UNITED STATES PATENT AND TRADEMARK OFFICE

Office Action Summary	Application No. 10/593,483	Applicant(s) HASEGAWA, MITSURU
	Examiner JOSEPH JOHNNIE	Art Unit 3767

DETAILED ACTION

F I G. 24.

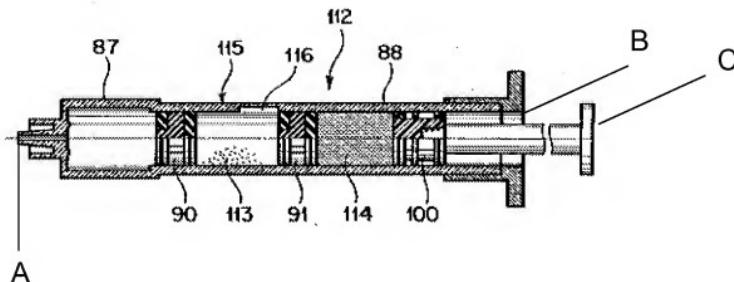
8. Re claim 1, Higashikawa discloses a pre-filled syringe comprising: a barrel 88, a tip in which a nozzle A is provided and an open base end B, an intermediate gasket 91 liquid-tightly partitioning an inside of the barrel into a front chamber and a rear chamber, a plunger gasket 100 located in a base end side of the intermediate gasket and sealing the inside of the barrel, and a plunger rod C connected to a base end of the plunger

gasket, and in which in a tip side of the barrel relative to the intermediate gasket there is formed a bypass 116 protruding outwardly in a radial direction (refer fig. 24 below),

wherein the intermediate gasket (91 from fig. 24) includes a seal part 105 contacting an inner wall of the barrel and liquid-tightly partitioning the front chamber and the rear chamber, and a bypass communication passage 92 providing communication between the front chamber and the rear chamber in cooperation with the bypass (refer figs. 17 and 18) and

wherein an axial length of the intermediate gasket 91 is longer than that of the bypass 116 and when an axial length of the bypass 116 is longer than the axial length of the seal part 105 (refer figs 18 and 24).

11. Re claim 9, Higashikawa discloses a tip gasket 90, an intermediate gasket 91, and a plunger gasket 100 in which the combined axial lengths of the three gaskets is less than the length from the tip of the nozzle to the base end of the bypass 116 (fig. 24).

12. Re claim 10, Higashikawa discloses a prefilled syringe wherein the barrel additionally comprises a tip gasket 90 and the front chamber is formed between the tip gasket and the intermediate gasket (fig. 24 above).

13. Re claim 11, Higashikawa discloses a nozzle member, the nozzle formed in the tip of the nozzle member, and the nozzle member including a tip gasket accommodation 87 capable of accommodating tip gasket 90, and a liquid passing passage through which a liquid medicine can pass when the tip gasket has been accommodated in the tip gasket accommodation part (fig. 24 above).
